CBER CMC BLA Review Memorandum

BLA STN 125700

**Nadofaragene firadenovec-vncg
ADSTILADRIN**

This memo reviews the Applicant's response to the CMC complete response letter (CRL) items. Please refer to the DMPQ and DBSQC memos regarding response to additional CRL items.

Figure 1: Vial label

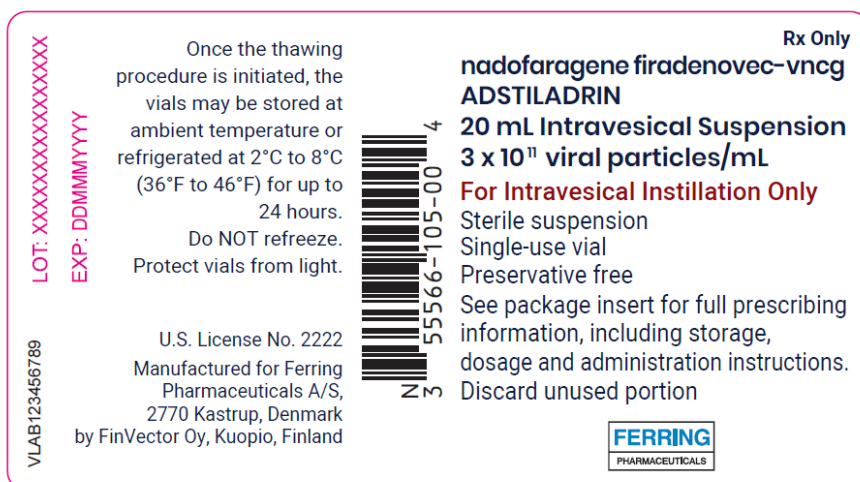
amendment 89 (December 2, 2022) to correct several issues that were not in compliance with 21 CFR 610.62. The Applicant revised the labels to correct proper name to be at least as prominent as the tradename, added suffix to and positioned the proper name above the trade name, added NDC number and “single-use vial” on the vial label, added “No U.S. standard of potency” to the carton label, removed certain ‘intervening material’ from the labels. The Applicant confirmed that one dose is 4 vials of the same batch. Multiple drug product lots cannot be supplied in one carton. The Applicant also confirmed that sufficient area of the vial remains uncovered from the label for its full length or circumference to permit inspection of the contents (a photo of labeled vial was provided). The final carton and vial labels were submitted in Amd #100 dated December 14, 2022.

The vial and carton labels (**Figure 1** and **Figure 2**) contain all required text.

Reviewer’s comment: The vial and carton labels are acceptable.
